Hi-Fi Products  
**Service Bulletin**

**Model:** CDP-491

**No. 298**

**Subject:** Display Board Change

CDP-491  
DISPLAY BOARD

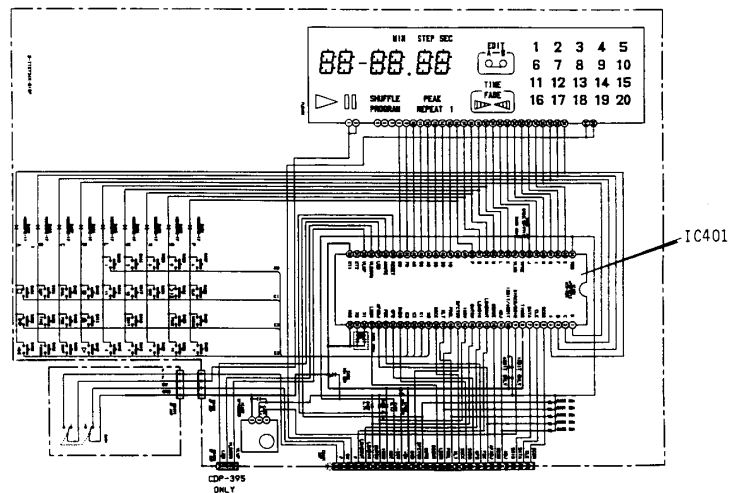
**Symptom:**  
(\*\*) The display board layout has been changed along with IC401 which has been changed to a DIP package type component.

**Solution:** Refer to layout drawing below when troubleshooting and to order IC401, refer to part number shown in chart:

REFERENCE	DESCRIPTION	PART NUMBER	
		INCORRECT	CORRECT
IC401	IC uPD75212ACW-A23	8-752-817-41	8-759-058-72
